LOCI Silage Pad

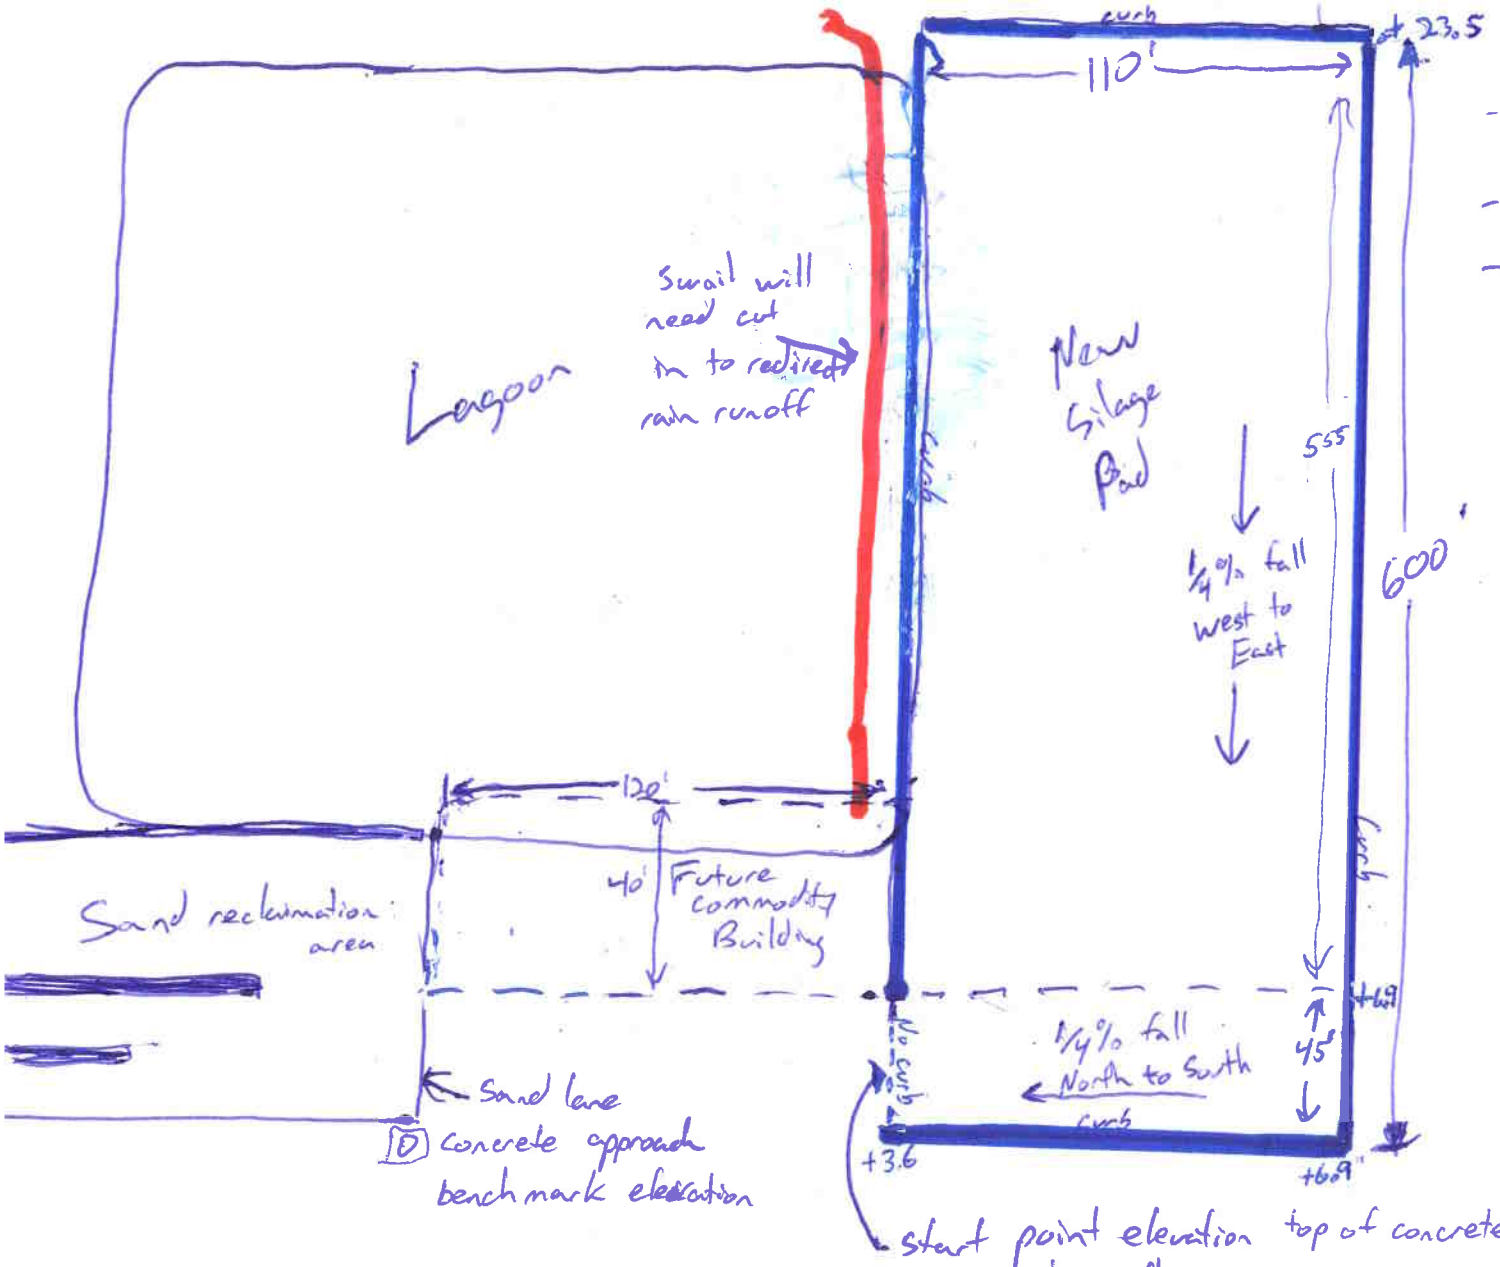
- all mesh needs elevated on chairs
- surface +/- ½"
- cure seal surface

start point elevation top of concrete 3½" higher than Sand lane approach
- No curb in 45' area on south side on east end
- curbing will be in place around remaining perimeter
